Evidence Submitted by Charles Martin to Planning Inspectorate Open Floor Meeting 12th January 2023.

Relating to the Proposed Alternative of Retaining A12 Junction 20A Southwest-Bound.

Scanned Options 1,2 and 3 (these plans are not to scale, hard copies to scale are available)

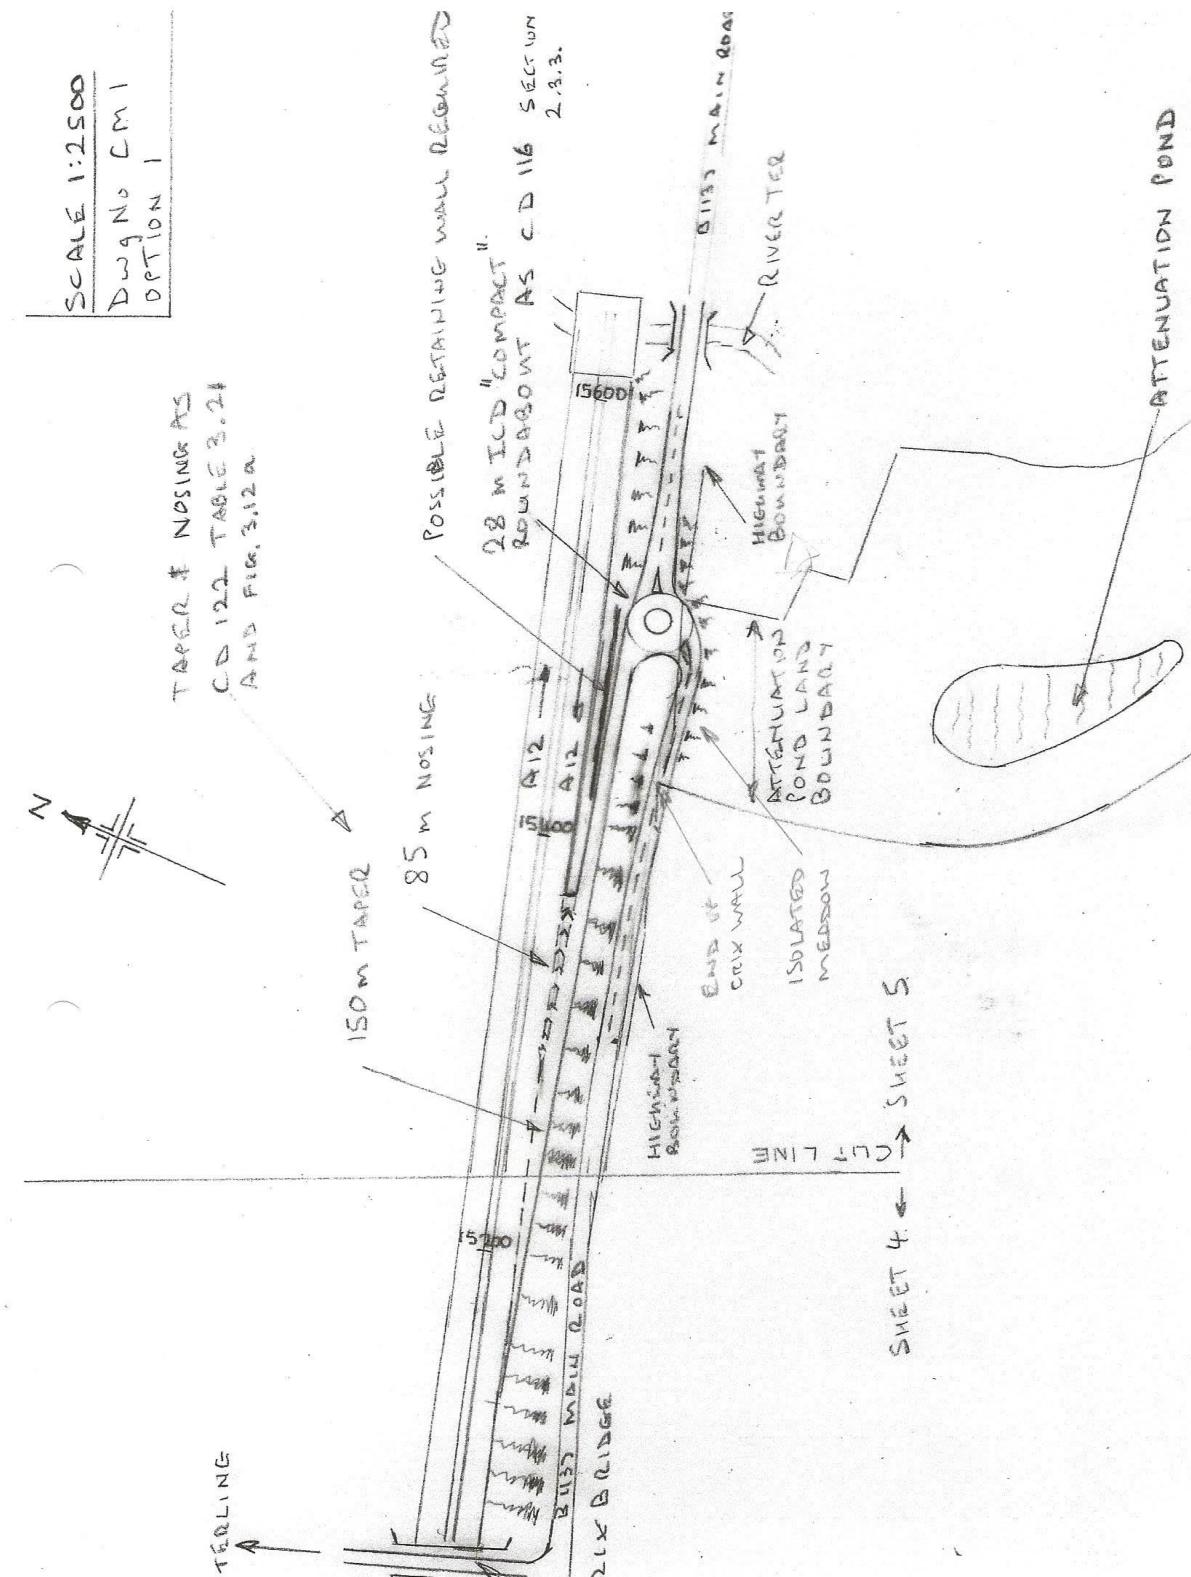
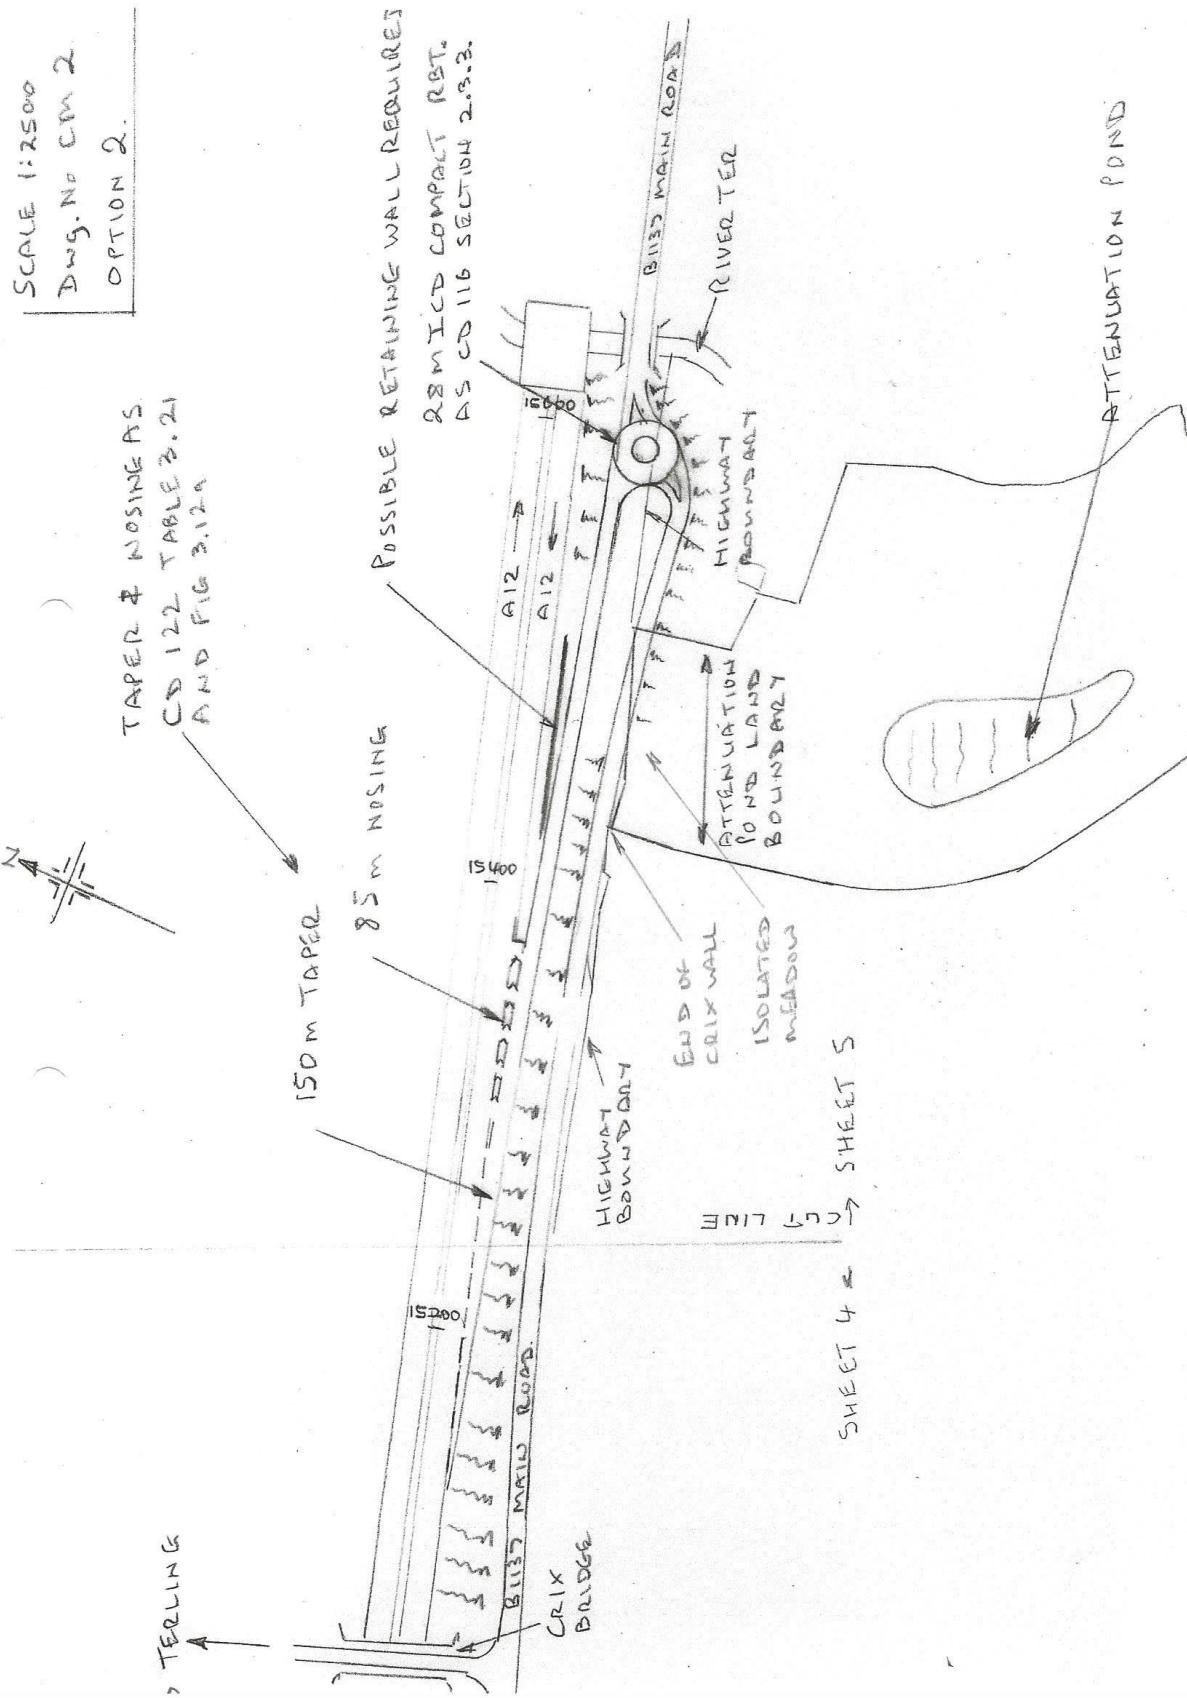
17. I have produced 3 Options (see Appendix B), which all start from the general premise of the existing northeast-bound lane of the B1137 to Hatfield Peverel being abandoned to give scope to move the proposed roundabout off-line to a degree.

19. My design Options 1 and 3 will have minimal effect on the last isolated section of the above wall northeast of the entrance gate to Crix House. It is hoped, detailed design of Option 2 at large scale could result in the wall being unaffected.

20. As part of NH's scheme design, the isolated meadow adjacent to the existing Junction 20A is to be laid out as land needed for a flood attenuation pond. As such it is assumed that this land will be acquired. Option 1 and 3 both utilise part of this land for the proposed roundabout. Whereas Option 2 moves the roundabout nearer to the River Ter bridge and would mean extra land take and a possible greater effect on the nearby cottages.

21. My preferred layout is Option 3. This gives a good entry deflection on all arms of the roundabout and would (along with all Options) accommodate the rare movement from the B1137 northeast bound back onto the A12. It is envisaged that some earthworks and regrading of the existing A12 cutting will be required to incorporate the necessary nosing and merge taper. It is noted that there are some telecommunication utilities on the B1137 verge and these may require diverting. It may be possible to avoid utility diversions by constructing a simple retaining wall within this cutting slope. There could also be a need for a small retaining wall adjacent to the A12 carriageway near the exit from the proposed roundabout to accommodate any level differences.
